Town of Hilton Head Island
Regular Design Review Board Meeting
Tuesday, May 22, 2018 – 1:15 p.m.
Benjamin M. Racusin Council Chambers
AGENDA

Town of Hilton Head Island
Minutes of the Design Review Board Meeting
April 24, 2018 at 1:15 p.m.
Benjamin M. Racusin Council Chambers

DATE: 05-1-2018
 PROJECT NUMBER: 01-17036
 SHEET TITLE: SITE PLAN

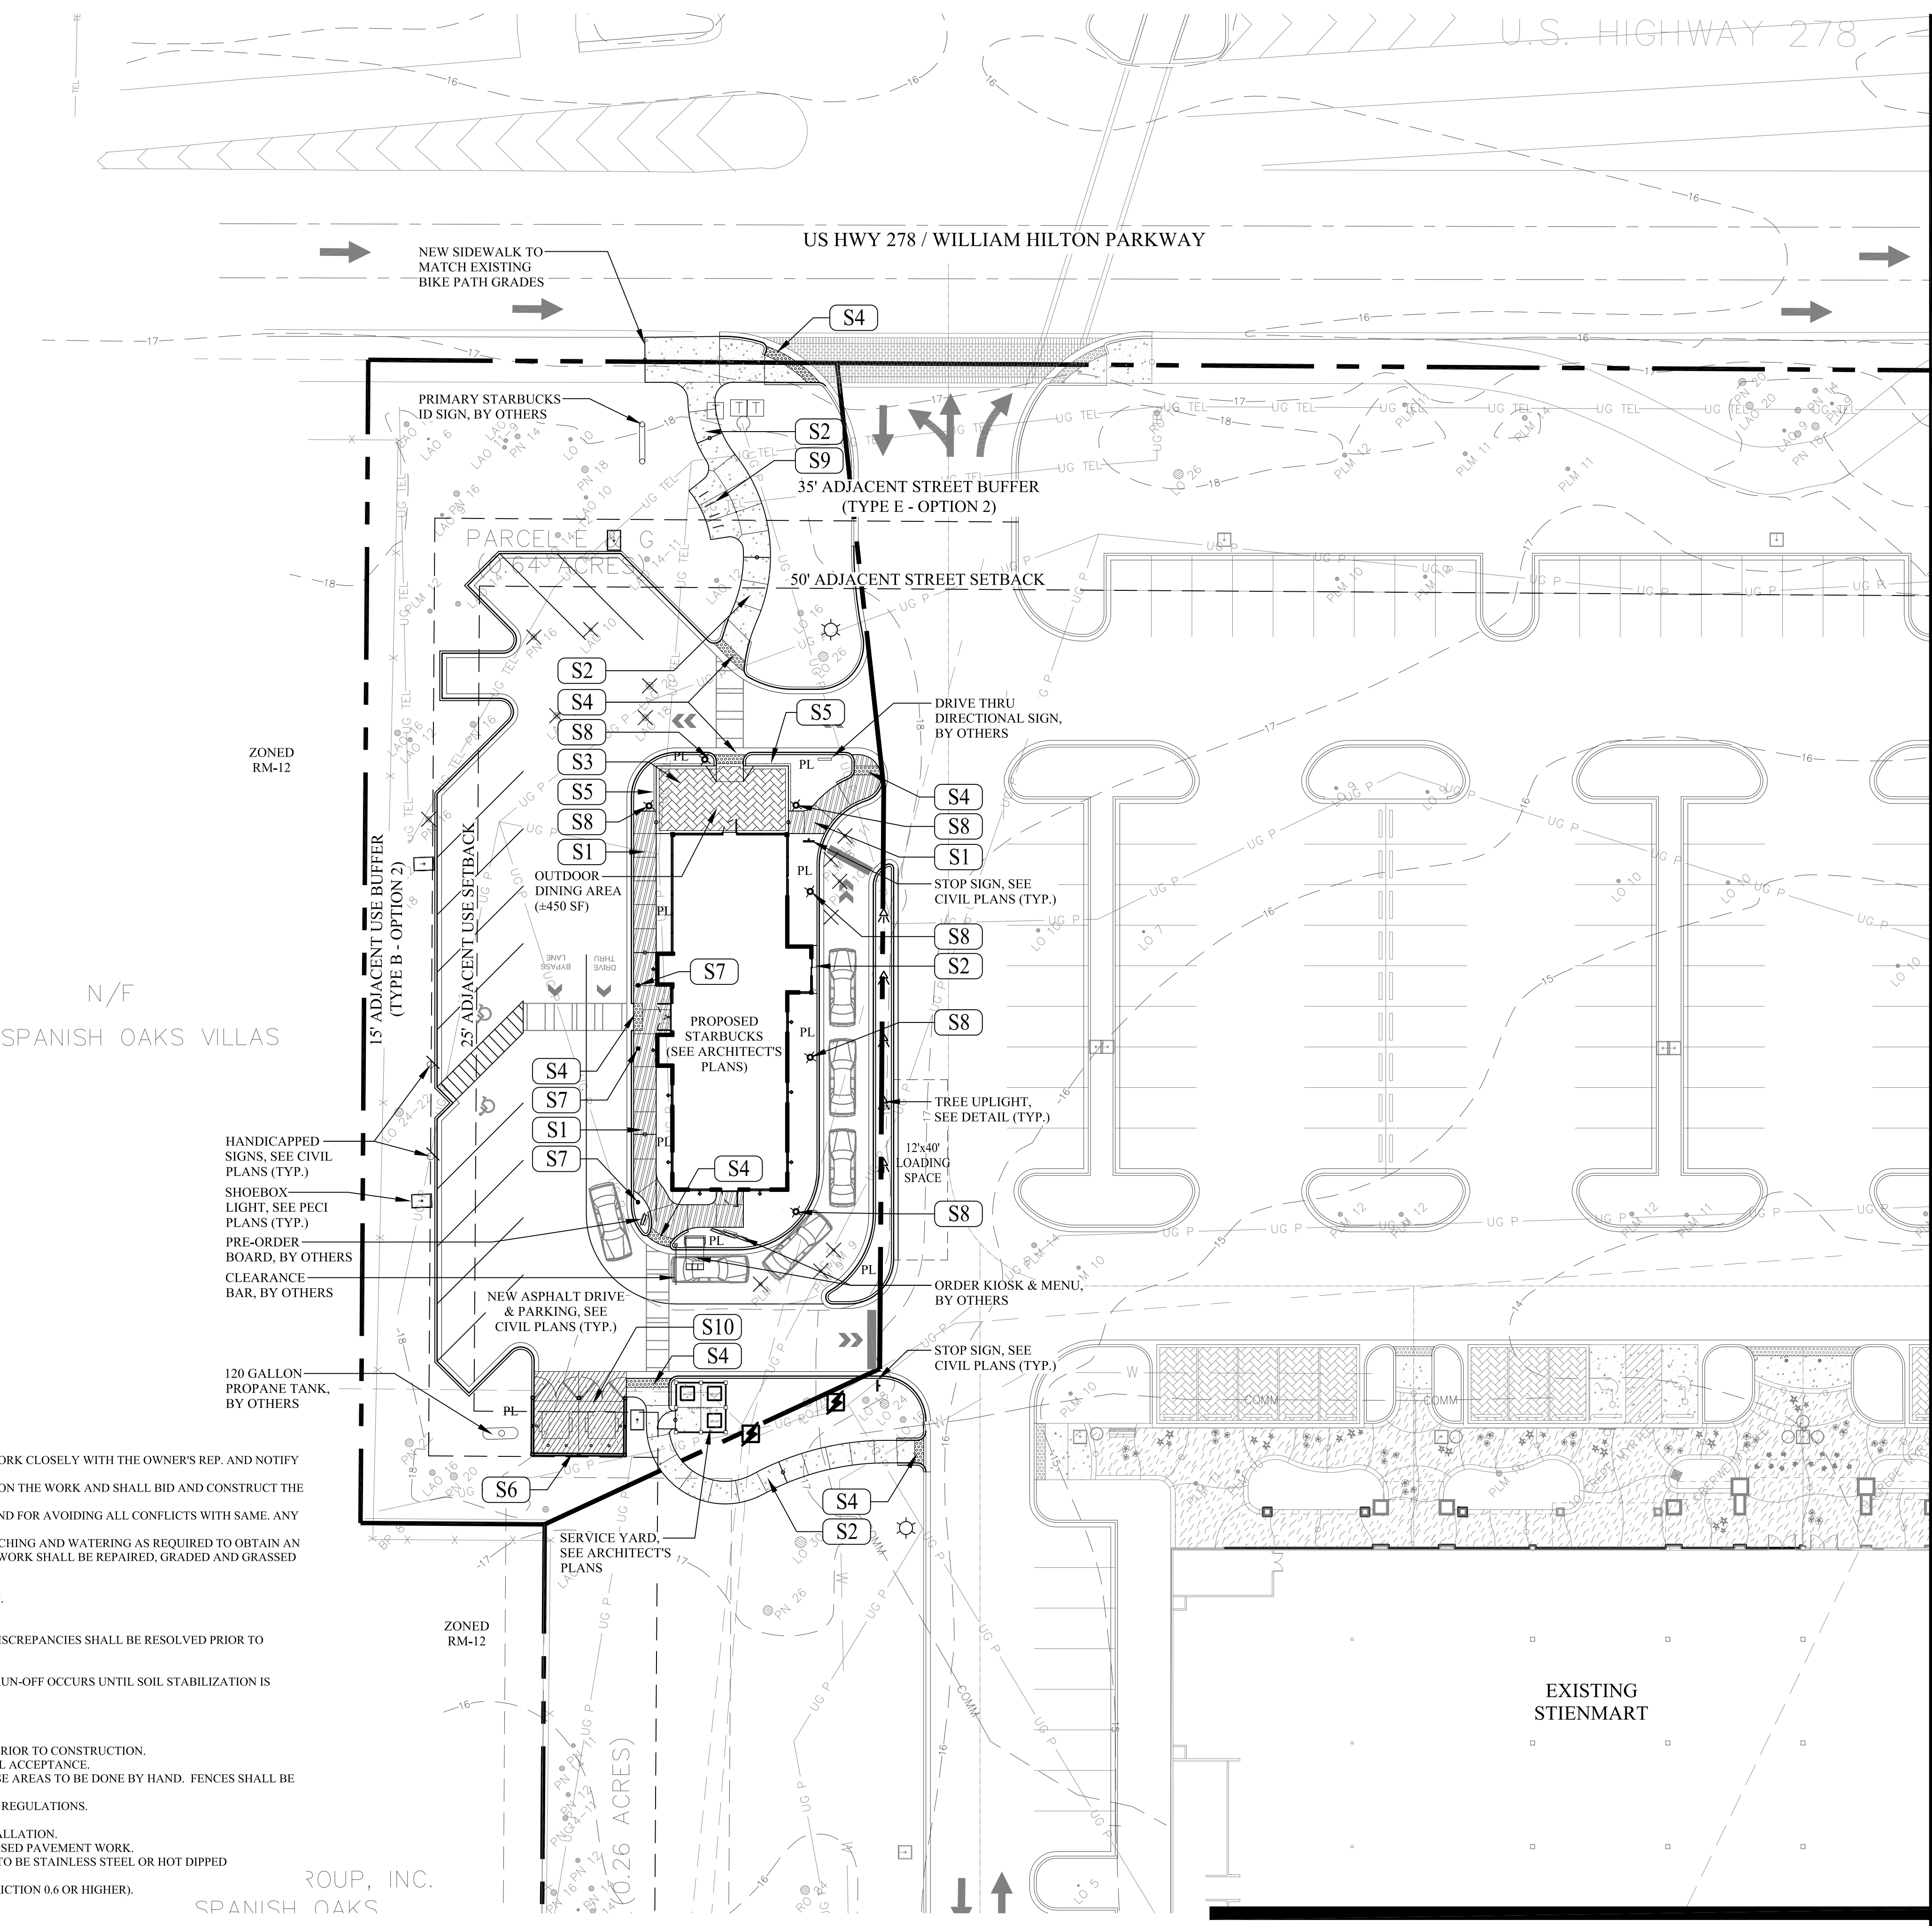
1. Remove curb beyond existing edge of asphalt with-in dripline of the 26 Live Oak at William Hilton Parkway.
2. Add bollard to protect ground from compaction with-in dripline of the 26 Live Oak at William Hilton Parkway.

In response to DRB preliminary comments, revisions were made to the land plan and landscape plan. In order to provide the 26" Live Oak with more space, the northern drive aisle was reduced to the LMO minimum of 14 feet and the plant bed between the outdoor patio and curb was slightly reduced. An agreement with staff was made to provide the 26" Live Oak in question with a pre-construction & post-construction feeding program. Bike racks have been added on site in the northern most buffer. Additionally, all Shell Ginger and Philodendron have been removed from the landscape plan.

C1 COMPOSITE LEFT ELEVATION
SCALE: 1/8" = 1'-0"

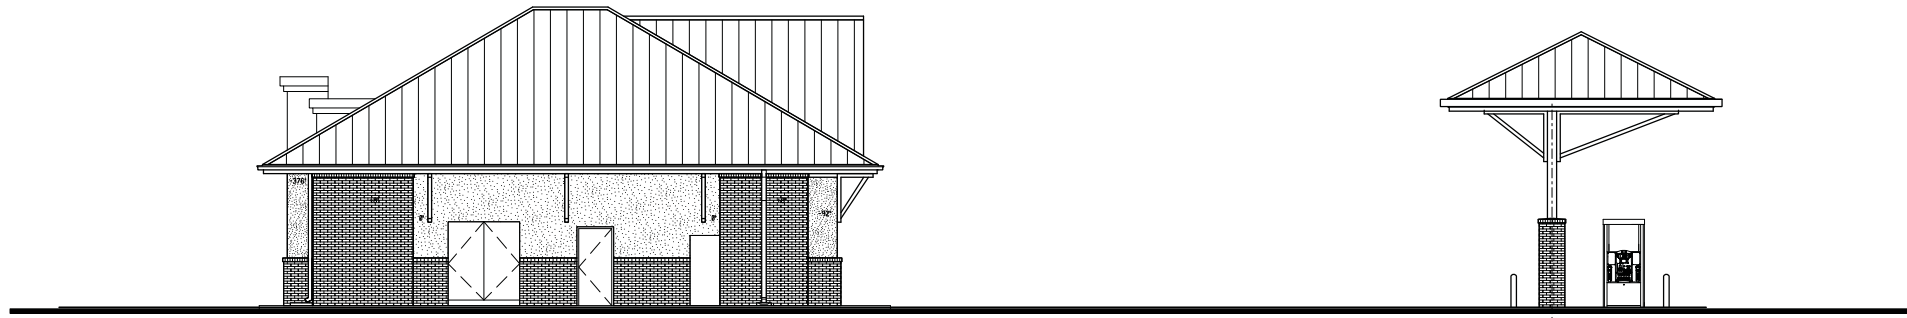
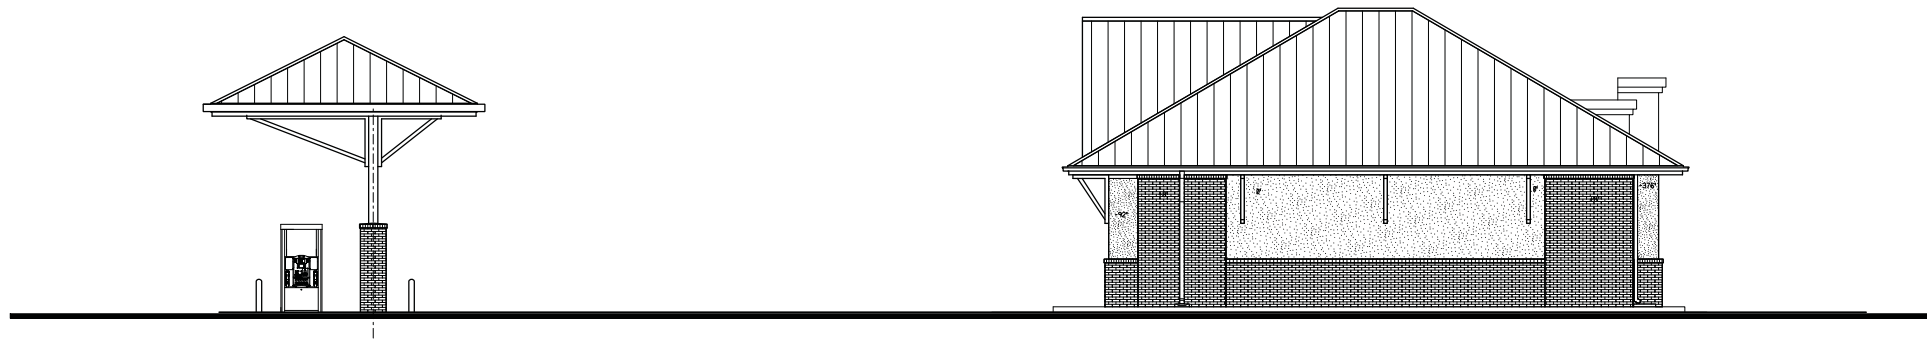
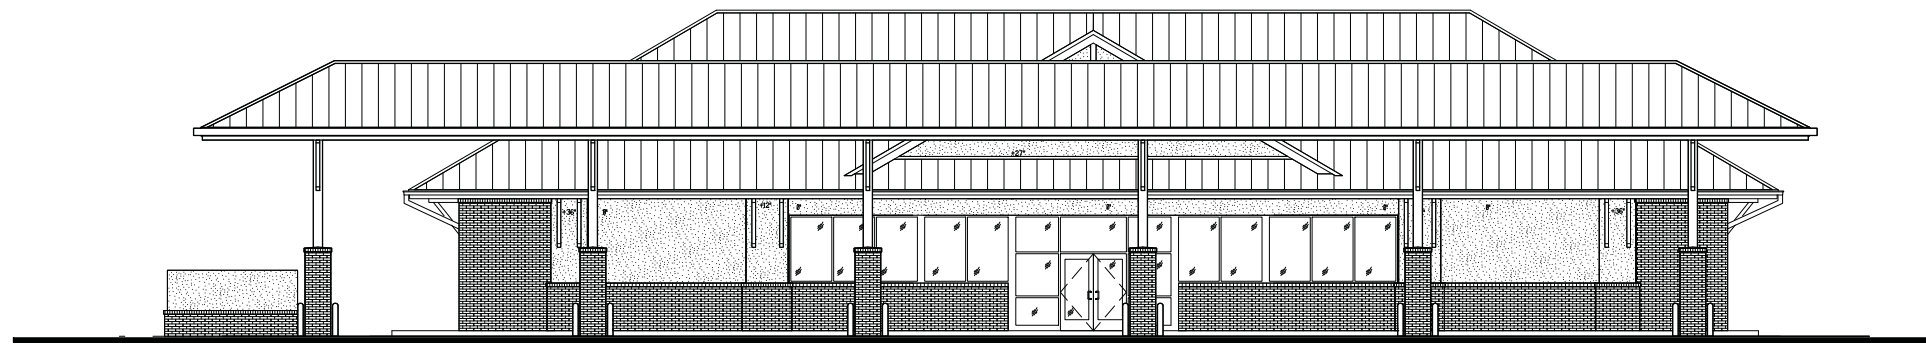
1. The building shall include a pitched roof. Utility wells on the back of the roof are acceptable.
2. Revise the planting plan per Staff comments and to meet the LMO requirements.
3. Revise the lighting plan per Staff comments and to meet the LMO requirements.
4. Provide a Tree Removal and Preservation Plan. Include the location of existing trees to remain on the Grading Plan.

The Board provided the following comments regarding the roof: on the left side elevation, the metal roof at the side entrance looks unnatural; the pronounced entry feature looks unnatural from the side elevations; flat roofs are generally not favored; a parapet roof all around may exacerbate the issue; relocate the mechanical equipment on the ground to achieve the pitched roof; address all four sides of the building; a creative parapet wall that has the façade of a finished roof may be an option to consider; pull back the front entry feature; provide the aesthetics of a pitched roof and allow for mechanical equipment.

1. The building roof shall be restudied to include a pitch.
2. The planting plan shall be revised per Staff comments.
3. The lighting shall be revised per Staff comments.
4. A Tree Removal and Preservation Plan shall be submitted.
5. The water table shall be converted to a brick water table.
6. The walk shall be extended north to the property line along Mathews drive.
